| ROADWAY PLAN                                                         |                                                    |
| INTERSTATE ROUTE H-1 RESURFACING                                     |                                                    |
| Miller Pedestrian Overpass to Kapiolani Interchange                  |                                                    |
| Federal-Aid Project No. NH-HI-1(279)                                 |                                                    |

| SHEET No. R5 OF 41 SHEETS                                            |                                         |

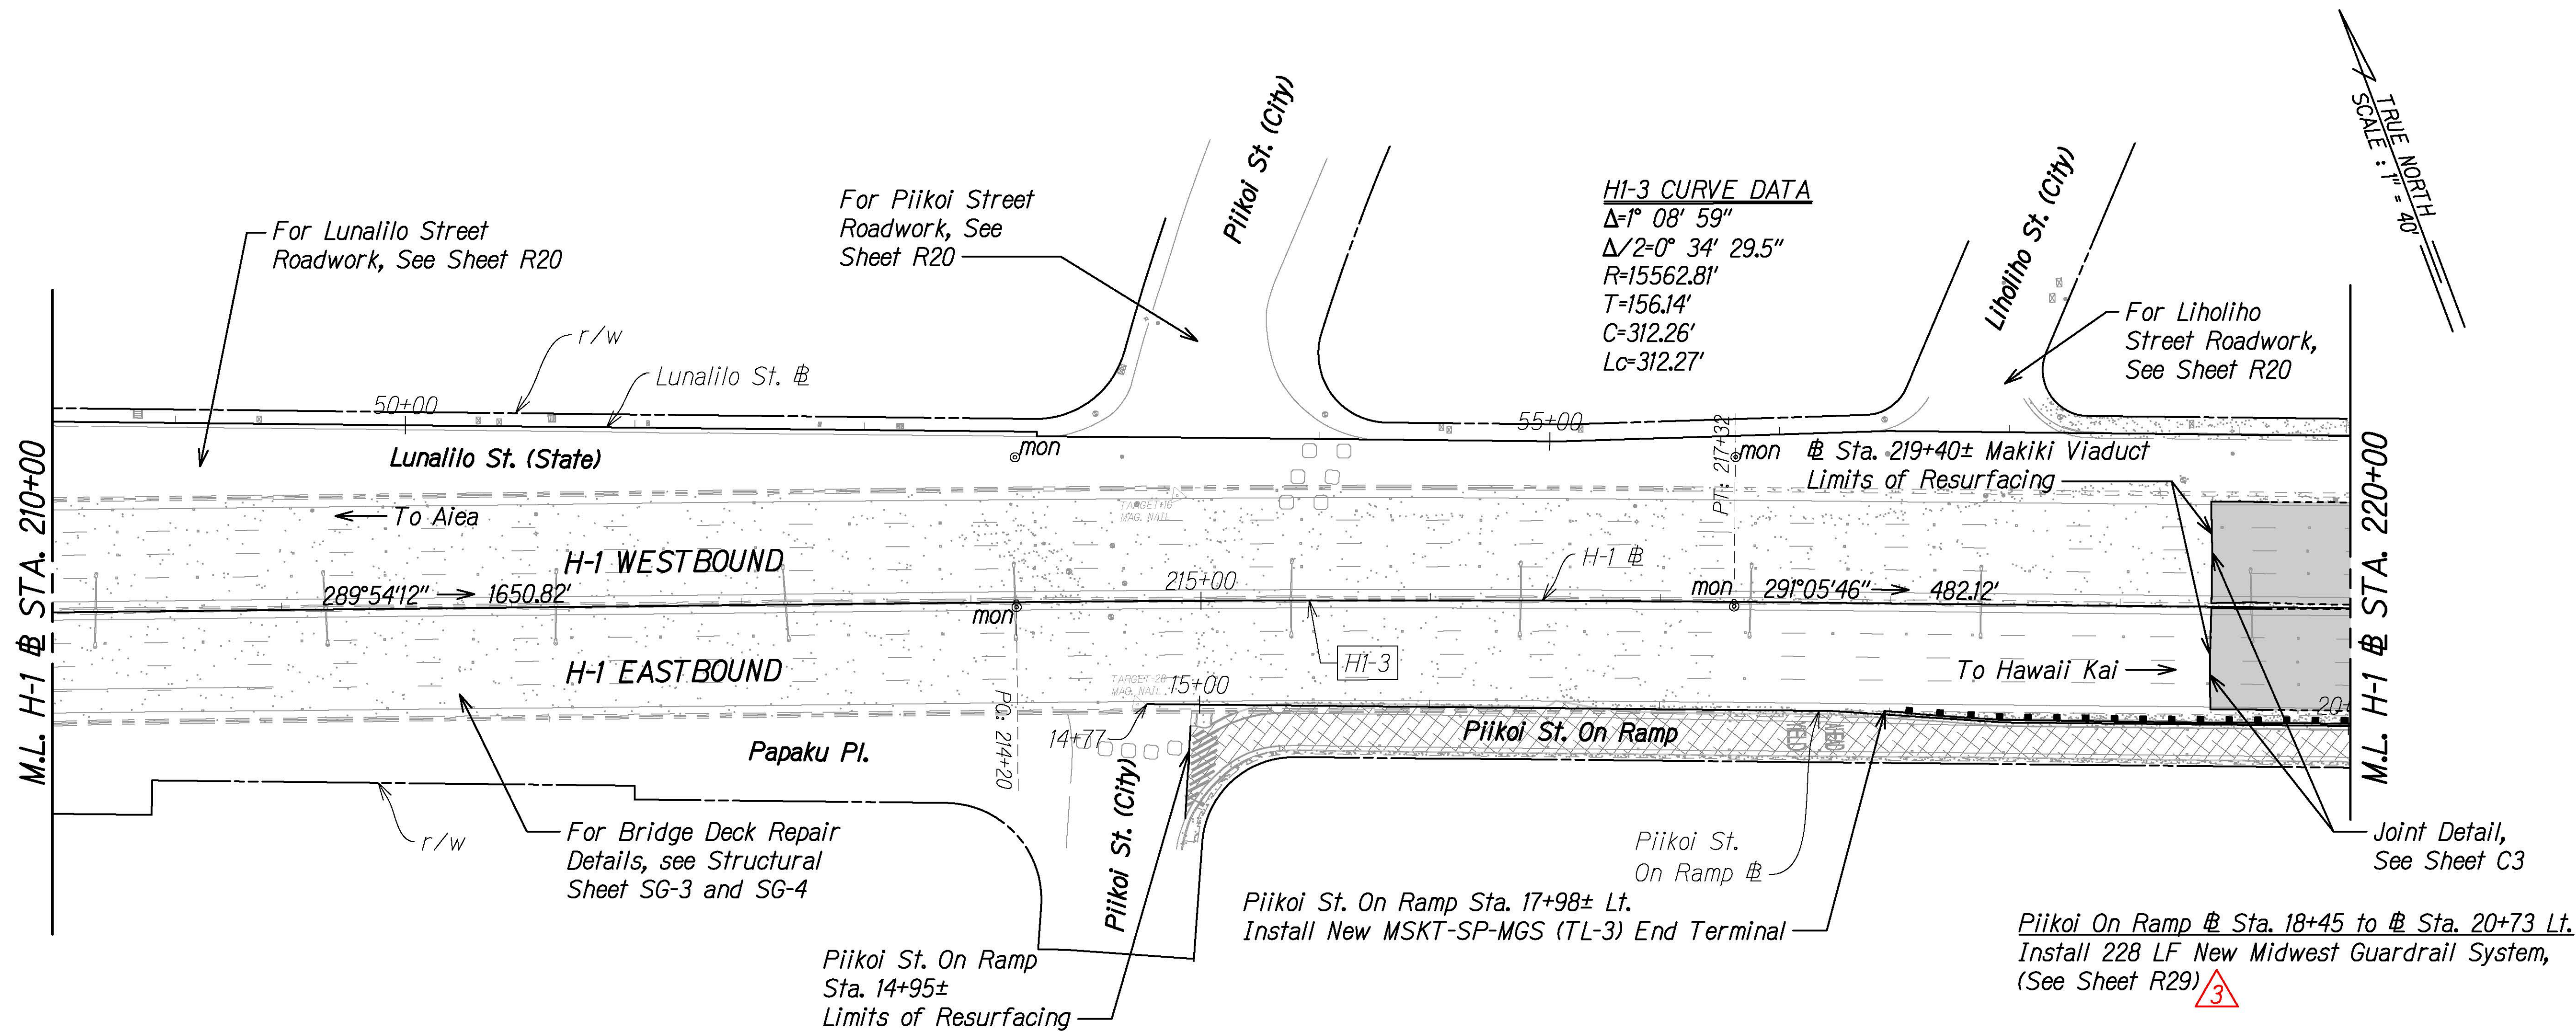
| 7/9/21                                                               | Revised Guardrails and Pavement Section |

| SHEET No. R6 OF 41 SHEETS                                            |                                                                                                     |

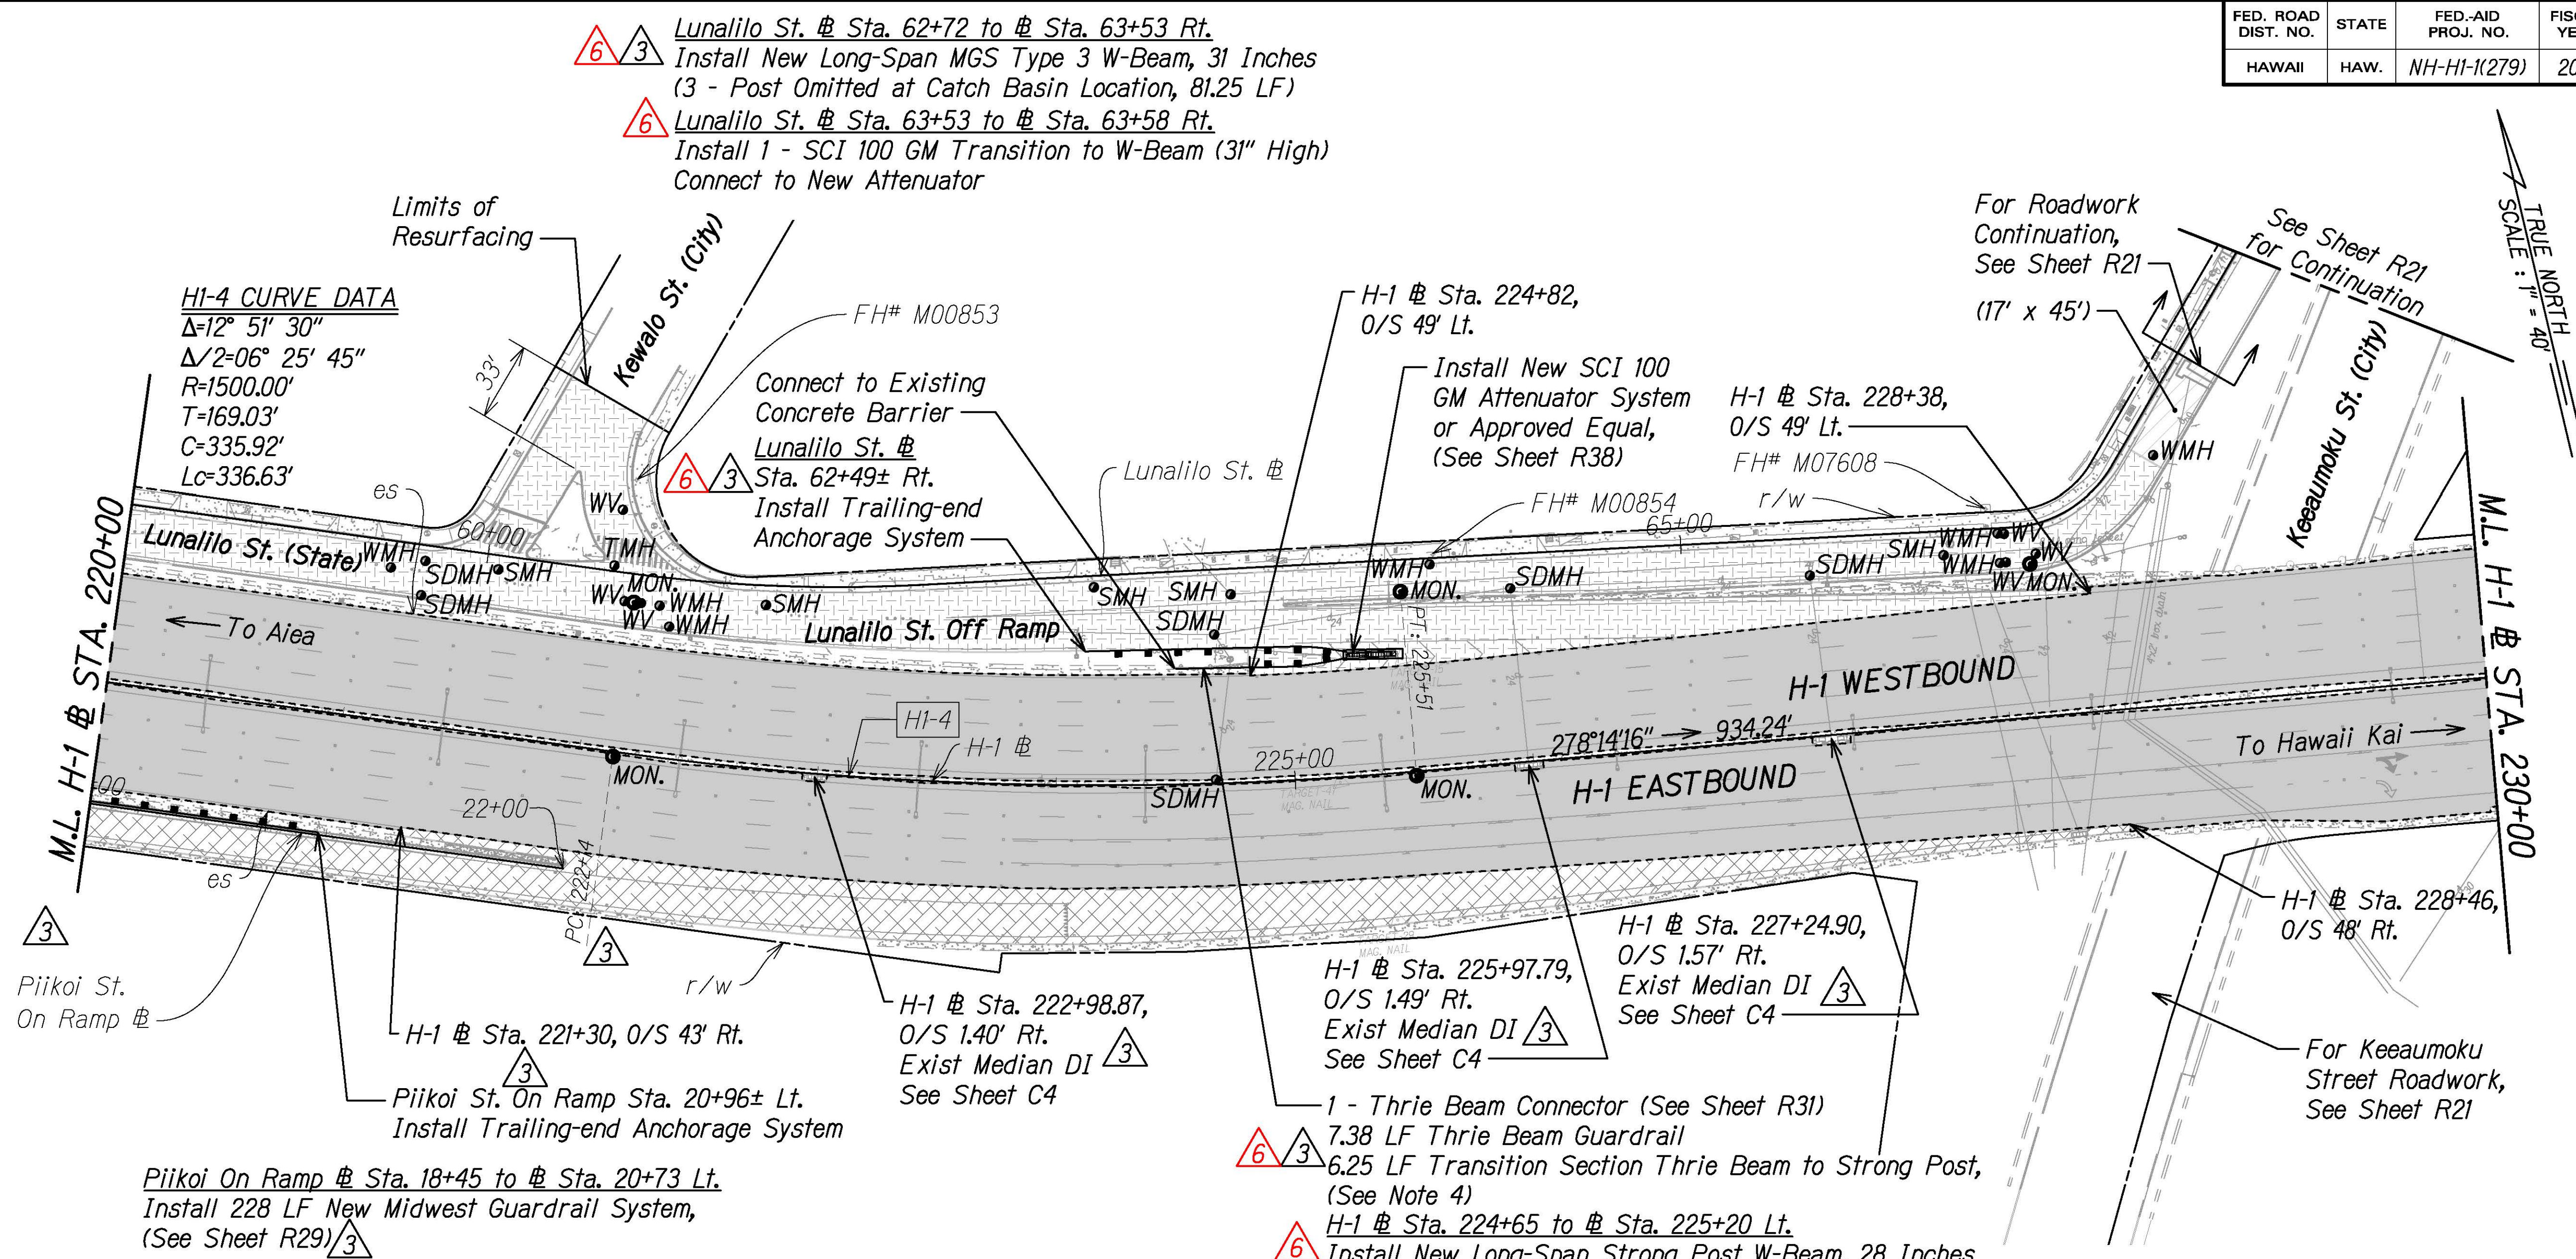
| 7/21/21                                                              | Revised Guardrails and Moved Attenuator                                                             |
| 7/9/21                                                               | BWS Tracings, Revised Guardrails Resurfacing Limits and Pav't Section, Added Exist. Median DI label |

| SHEET No. R7 OF 41 SHEETS                                            |                                                                             |

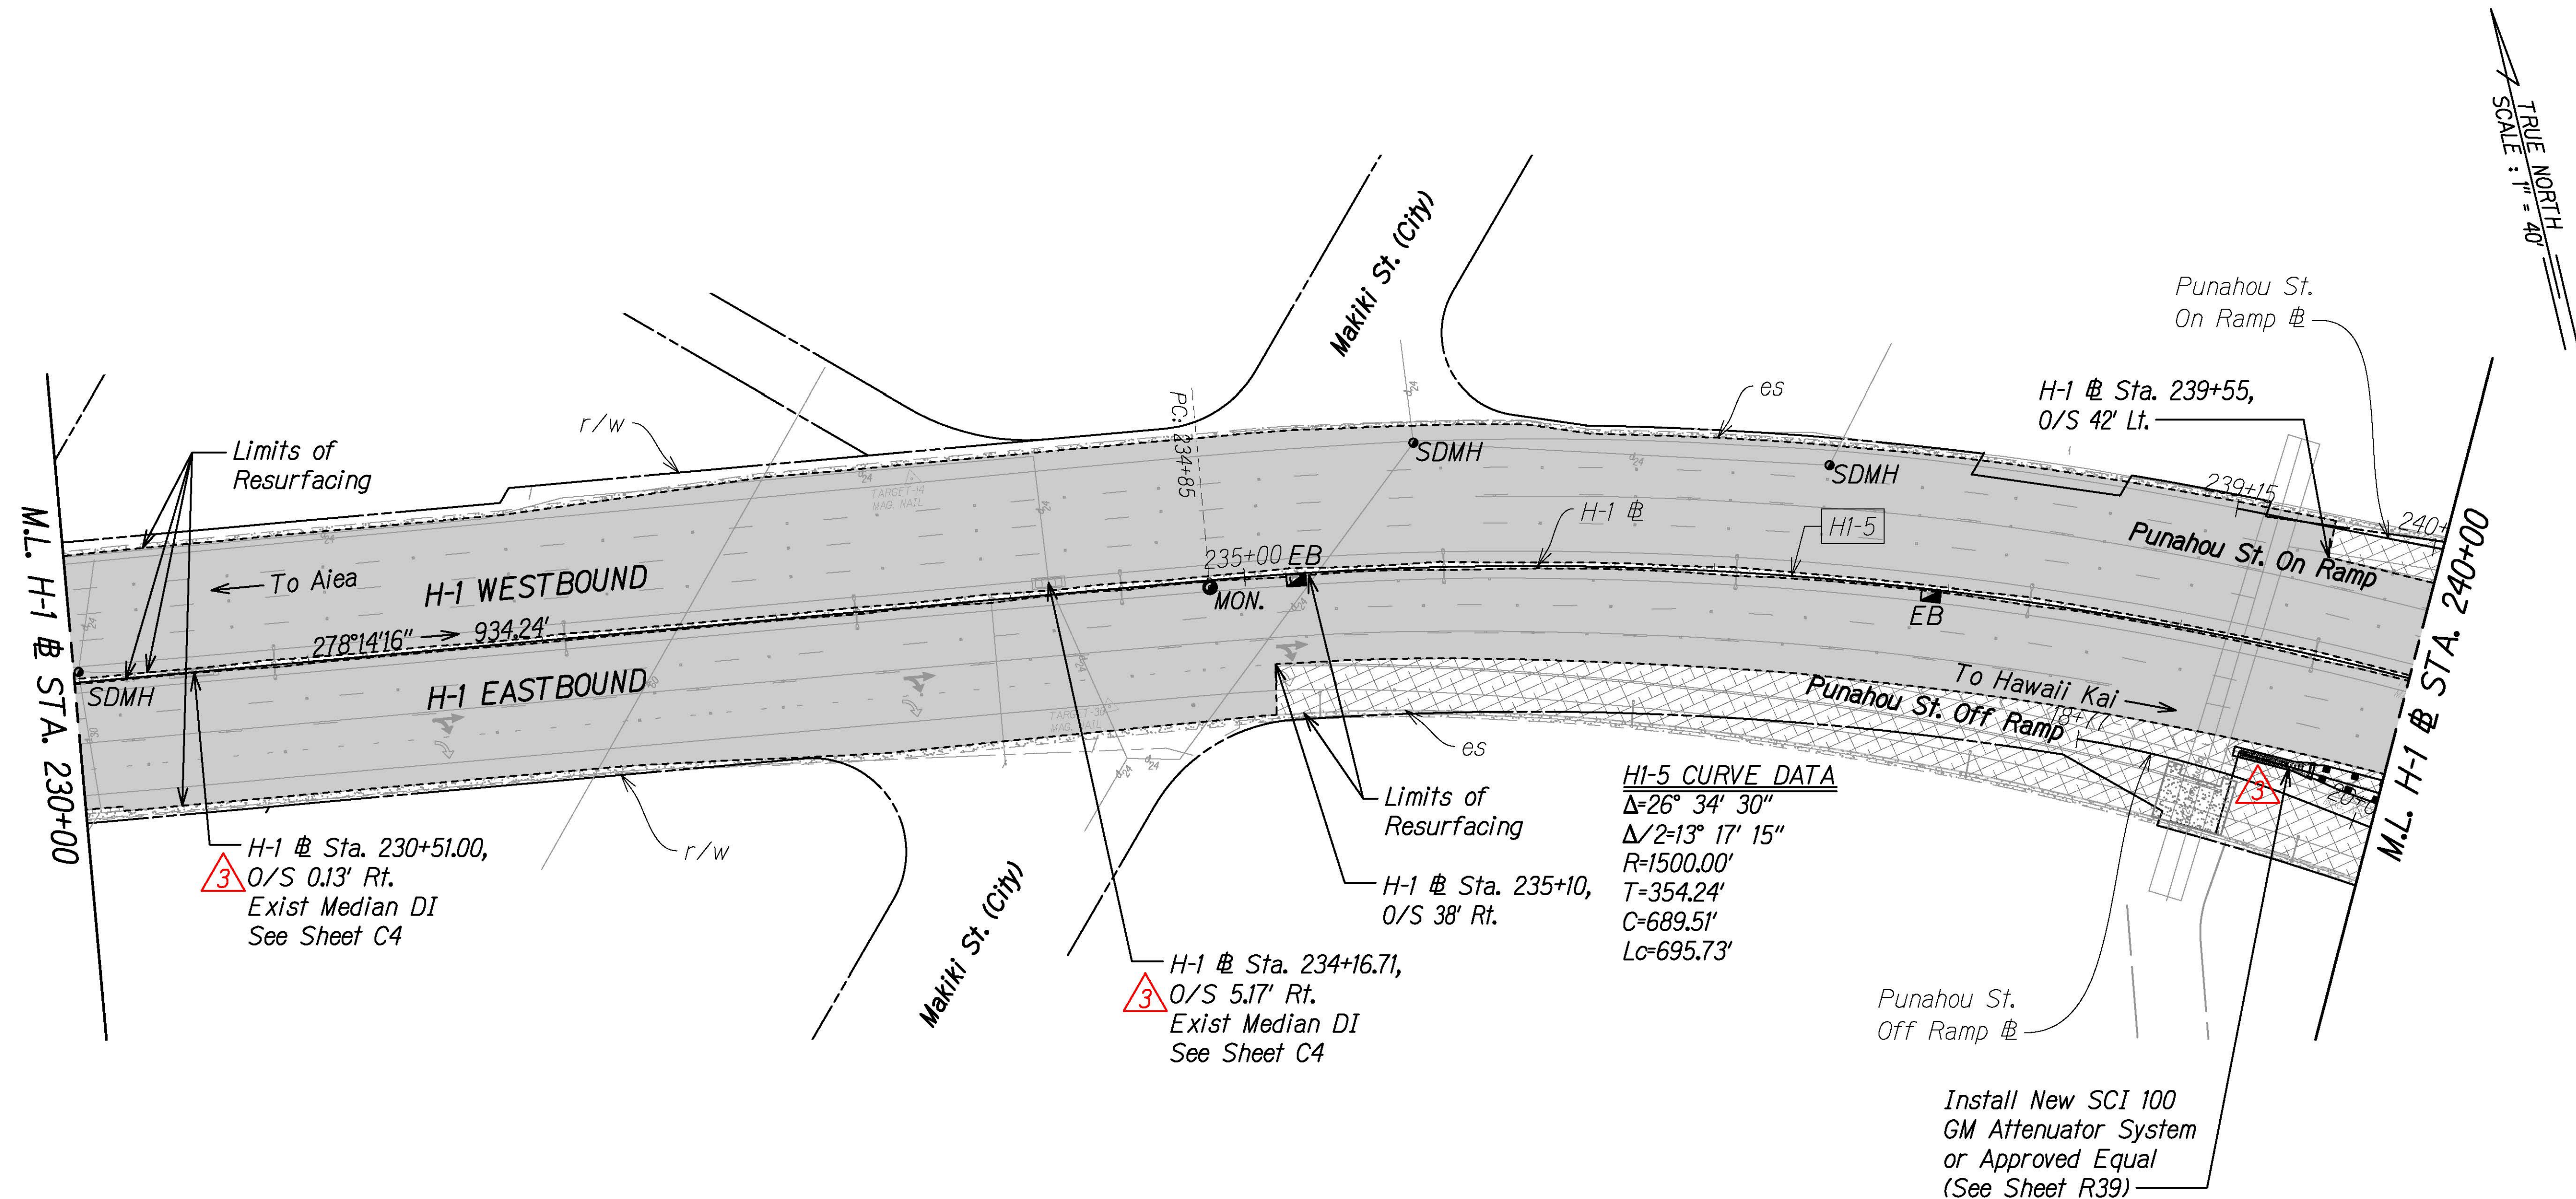
| 7/9/21                                                               | Revised Guardrails and<br>Pavement Section, Added Exist.<br>Median DI label |
